MHI Position on Basic SPM withdrawal Issue

US-APWR Design Certification

RAI NO.:	NO.702-5518 REVISION 0
SRP SECTION:	07.06 – INTERLOCK SYSTEMS IMPORTANT TO SAFETY
APPLICATION SECTION:	07.06
DATE OF RAI ISSUE:	02/28/2011

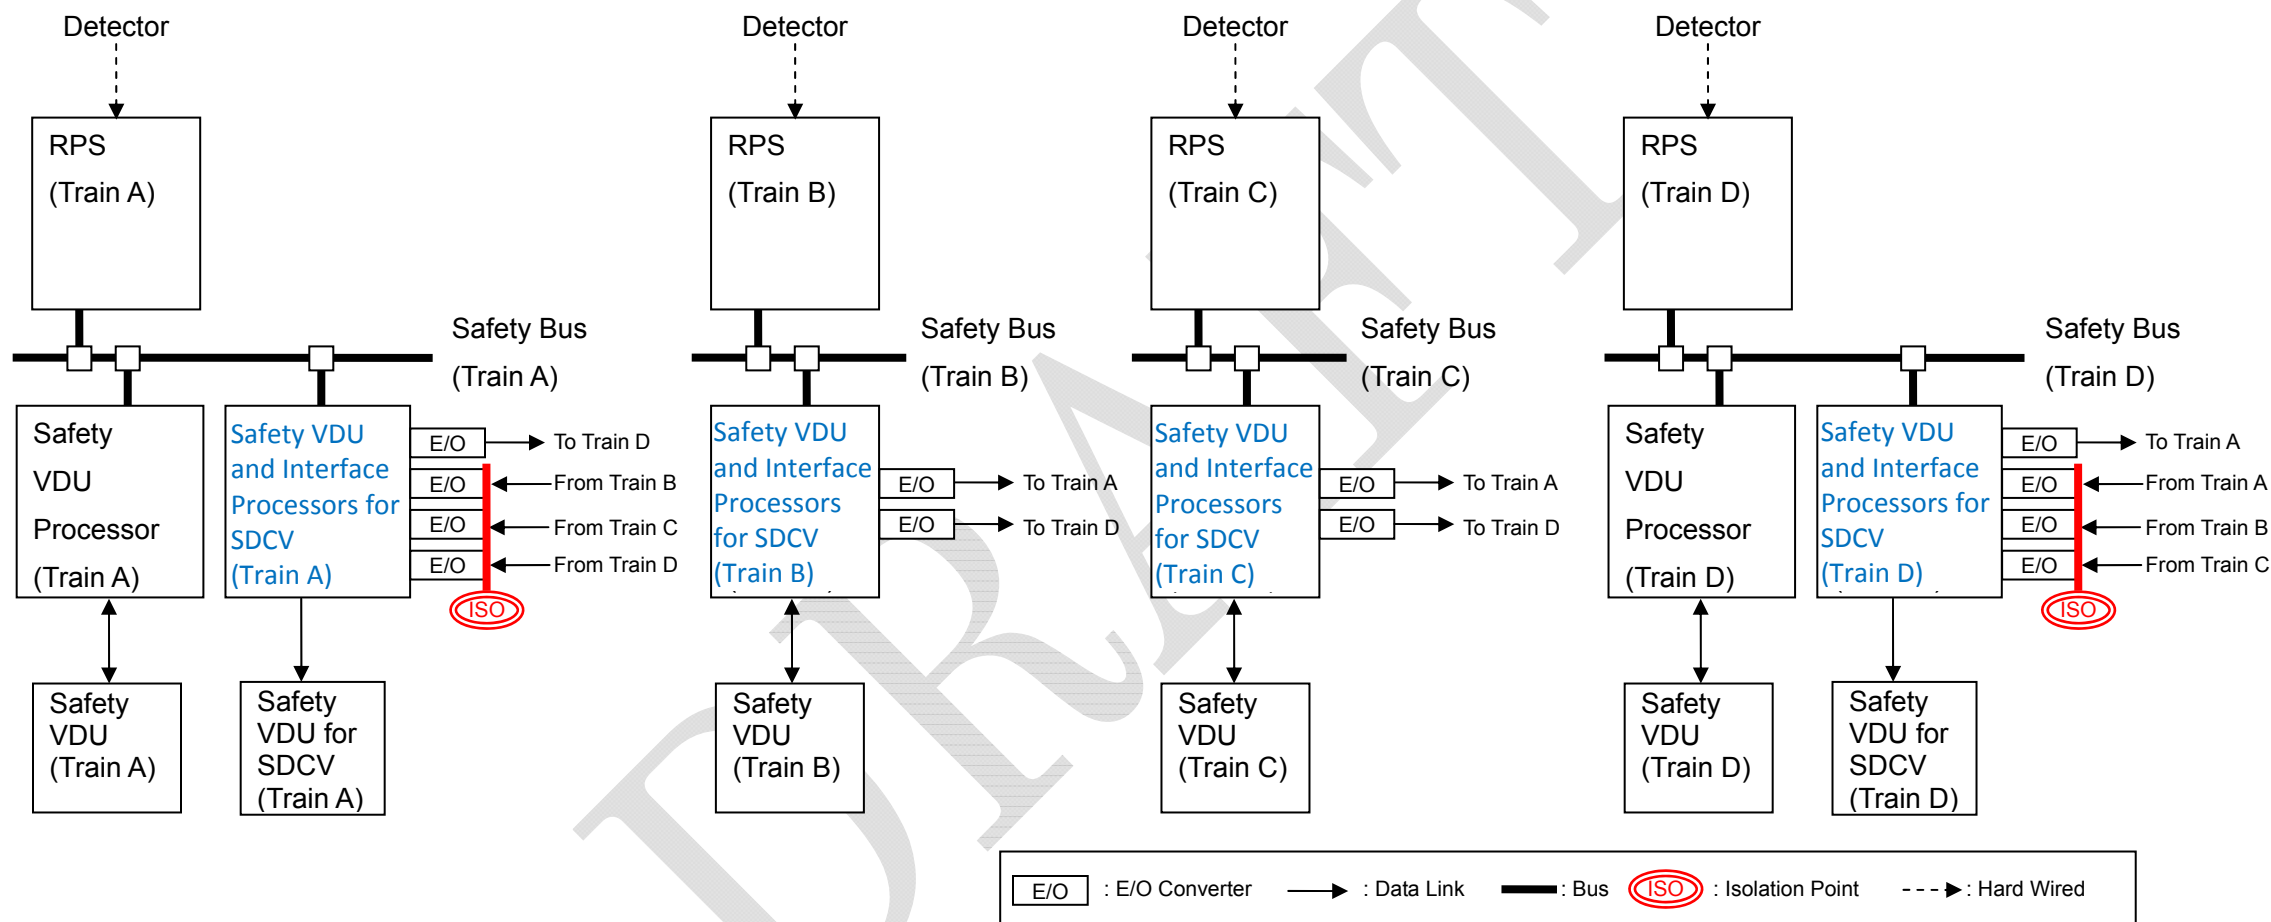
In the US-APWR Phase 1 V&V, a scenario for the loss of all non-safety HSI was simulated and the dynamic validation by using PWR simulator was conducted. As a result of the validation, the human engineering discrepancy (HED) regarding;

- Situation awareness for plant overall status
- Task burden (navigation of in or between safety VDU screens)
- Ability to use soft controls and monitoring in coordination
- Necessity alarms on safety VDU to initiate operator action

were raised for safety VDU design (see Part 3 Section 4.2.5 and 5 of Reference 2).

To resolve these HEDs, MHI considered additional spatially dedicated, continuously visible (SDCV) displays to be added adjacent to the train dedicated safety VDUs.

In order to resolve the HEDs described in Section 1, MHI is planning to add two more safety VDUs, each which is included in train A/D, but both of them have uni-directional serial data link interface with other trains of A to D. The added safety VDUs has ability to display following parameters in SDCV manner:

- Regulatory Guide 1.97 Category 1 parameters (IEEE-497 type A, B and C: DCD Chapter 7)
- Plant process indications that would lead operators to take action in SAR of the US-APWR DCD Chapter 15

It is noted that the mentioned safety VDUs for SDCV display has no control functions, but has only monitoring function

Using of the safety VDUs SDCV is expected to resolve the HEDs by reducing of operator's task burden to request display screens, and providing continuous display and alerting function to take required actions.
